AS/NZS CISPR 16.1.4:2020
Specification for radio disturbance and immunity measuring
apparatus and methods
Part 1.4: Radio disturbance and immunity measuring apparatus —
Antennas and test sites for radiated disturbance measurements (CISPR
16-1-4:2019 (ED 4.0) MOD)

Amendment No. 2

Part 1-4: Radio disturbance and immunity measuring apparatus – Antennas and test sites for radiated disturbance measurements

AMENDMENT 2

Figure 34 – Example of size-compliant loop antenna

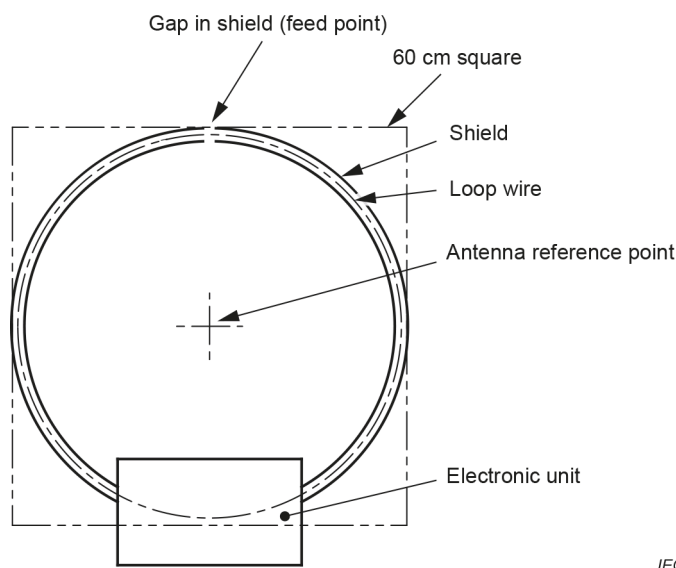
A shielded loop antenna of dimensions such that the loop antenna can be completely enclosed by a square having sides of 60 cm in length shall be used. The shielding, but not the electronic unit including mechanical mounting features and connected cables, shall be taken into account when applying the size criterion; see Figure 34.

NOTE This example illustrates the maximum diameter circular-shaped loop antenna that still complies with the size criterion.

Figure 35 – General arrangement of the three measurement orientations H_x , H_y and H_z , where d is the measurement distance and h is the height of the reference point

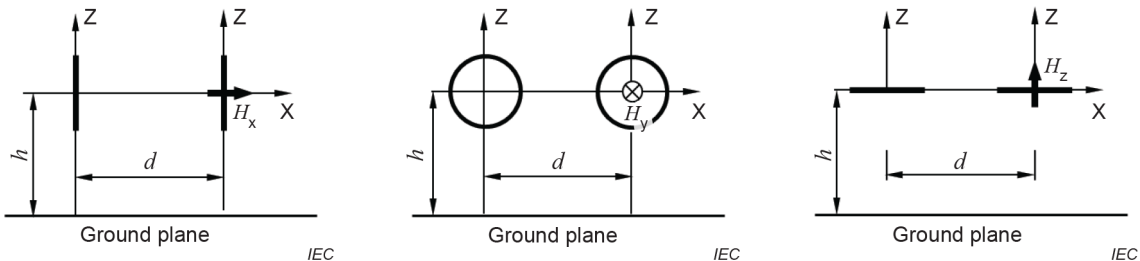
Three different loop antennas orientations shall be measured according to Figure 35. The measurements shall be performed in the frequency range from 9 kHz to 30 MHz, with frequency steps less than or equal to those specified in Table 9.

Figure 36 – Antenna positions

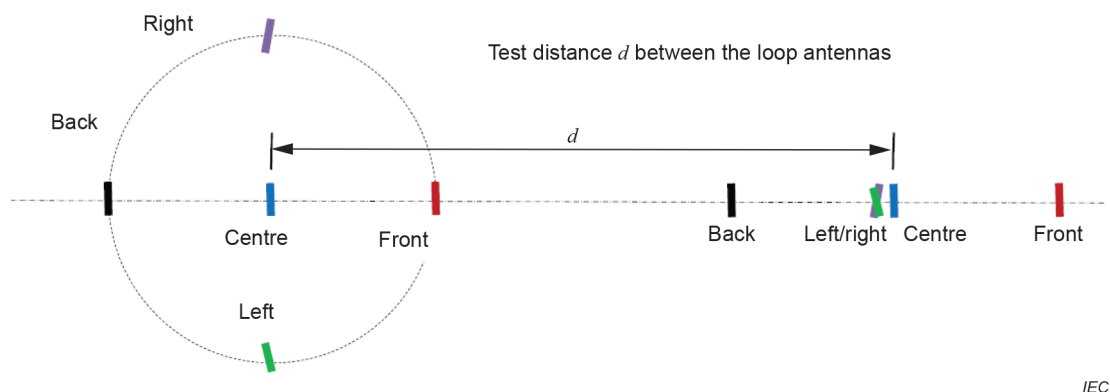
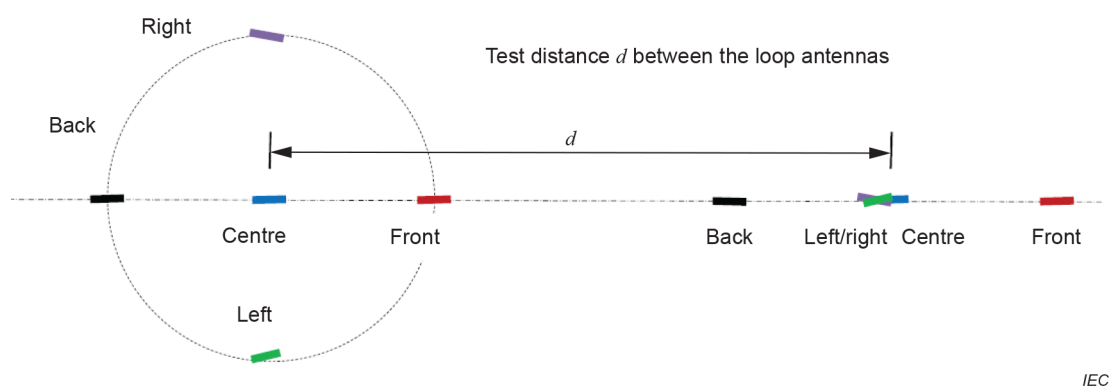
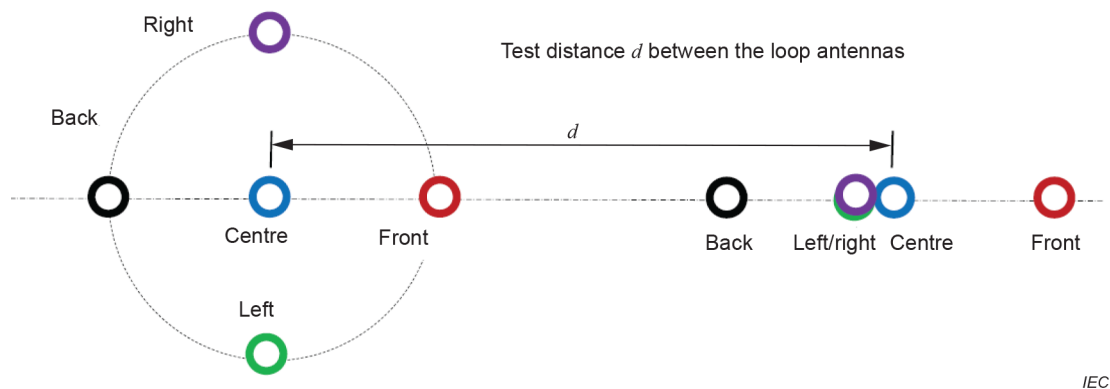
Loop antennas conforming to the requirements of 4.3.2 shall be used for these measurements. Distances are measured with respect to the reference points of the antennas. The measurement heights for the transmit antenna and the receive antenna are fixed at 1,3 m from the ground plane to reference points of the loop antennas. Height scanning is not required for either antenna. The reference point of the transmit antenna shall be placed at the required locations in turn: centre and four locations (left, right, front, rear) on the perimeter of the test volume to be validated, in accordance with Figure 36 and Figure 37.

Figure 36 and Figure 37 illustrate the measurement positions in the test volume. Five positions in the test volume shall be measured. The measurement distance d shall be kept constant.

NOTE The receive loop antenna positions corresponding to the left and right transmit antenna positions, shown with green and magenta colors respectively, are one and the same. However, these are shown with a slight offset in the diagram so that both are visible.
